QUALITY ASSURANCE -- NON-CONFORMANCE REPORT

Location: Changxing Island, Shanghai, PRC **Report No:** NCR-000440
Prime Contractor: American Bridge/Fluor Enterprises, a JV **Date:** 04-Oct-2009
Submitting Contractor: Zhenhua Port Machinery Company, Ltd (ZPMC), Changxing Island **NCR #:** ZPMC-0414

Reference Description: Missed Class A UT indications on Strut Web Connection Angle ED1-SA183-38M-4

To:	AMERICAN BRIDGE/FLUOR, A JV 375 BURMA ROAD OAKLAND CA 95607	**Date:**	06-Oct-2009
		Contract No:	04-0120F4 04-SF-80-13.2 / 13.9
Dear:	Mr. Charles Kanapicki	**Job Name:**	SAS Superstructure
Attention:	Mr. Thomas Nilsson Project/Fabrication Manager	**Document No:**	05.03.06-000403
Subject:	NCR No. ZPMC-0414

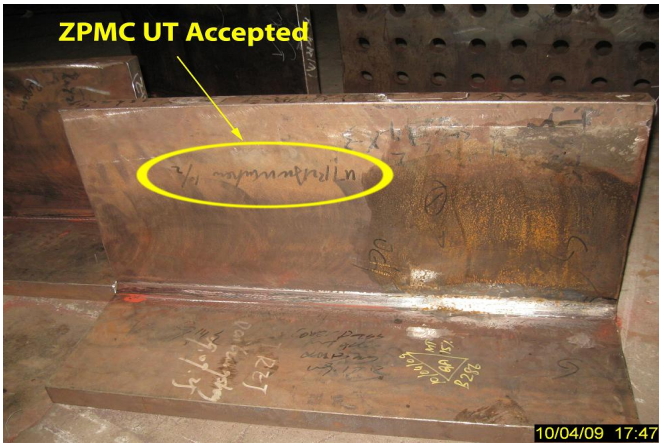
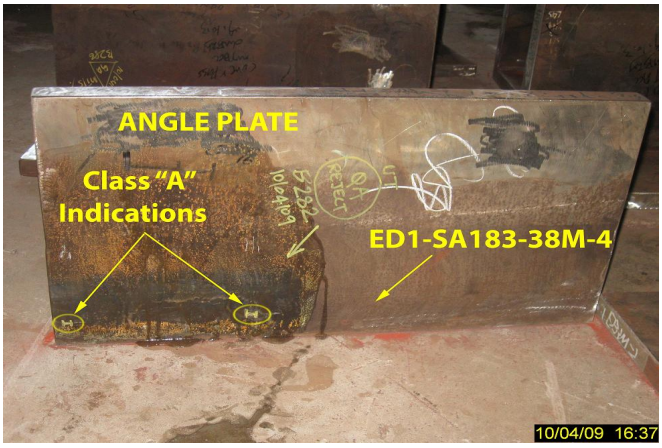
During Ultrasonic Testing (UT) of Strut Web Connection Angle weld joint ED1-SA183-38M-4, QA discovered class “A” rejectable indications measuring approximately 12mm and 10mm in length. This weld was previously tested and accepted by ZPMC Quality Control (QC) UT technicians (NDT Inspection Notification Sheet #004346).

AWS D1.5-2002, Section 6.26.3.1 - "Welds that are subject to UT in addition to visual inspection shall be acceptable if they meet the following requirements: (1) Welds subject to tensile stress under any condition of loading shall conform to the requirements of Table 6.3)."

Contract Plans, Sheet 9, General Notes No. 4 - "Web Connection PL" is designated as TM/SRM (Tension Member/Stress Reversal Member)
